PCN / EOL Notification

Product Change Notification Number: CC072601

Title: AT24C256B New Catalogue Part Number & Physical Part Marking Schemes and Conversion to NiPdAu plating for SOIC, TSSOP and ULTRA THIN SAP packages

New catalogue part number scheme

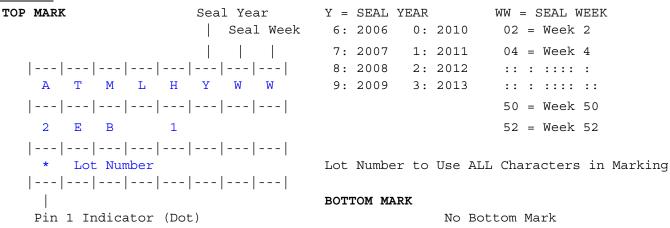
- -Eliminating "-10"
- -Eliminating voltage designator (designating 1.8v).
- -Adding suffix "-B" to the catalogue part number will denote bulk form.
- -Adding suffix "-T" to the catalogue part number will denote Tape and Reel requirements.

As the new catalogue part number will incorporate Tape and Reel requirements, the need for Tape and Reel SL's will be eliminated.
